MILITARY SPECIFICATION

MICROCIRCUITS, DIGITAL, MOS, 4096 BIT STATIC RANDOM ACCESS MEMORY (RAM), MONOLITHIC SILICON

This amendment forms a part of Military Specification MIL-M-38510/238A, dated 9 March 1981, and is approved for use by all Departments and Agencies of the Department of Defense.

FIGURE 2. Block diagrams.

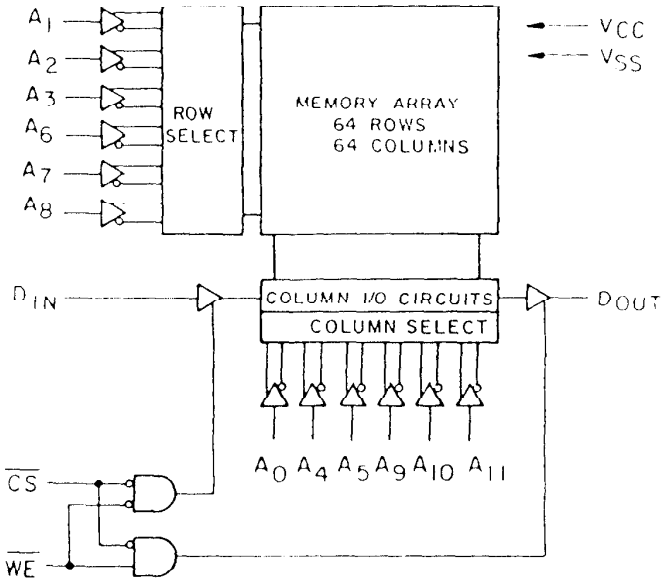
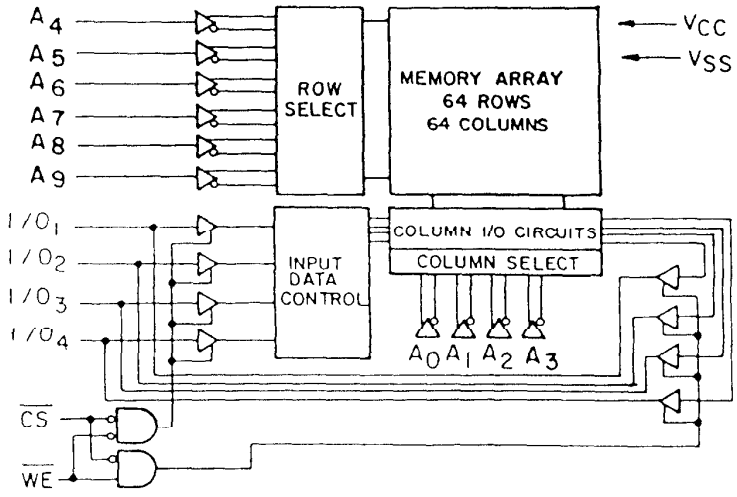
FIGURE 2, delete and substitute new figure 2 as printed on page 2 of this amendment.
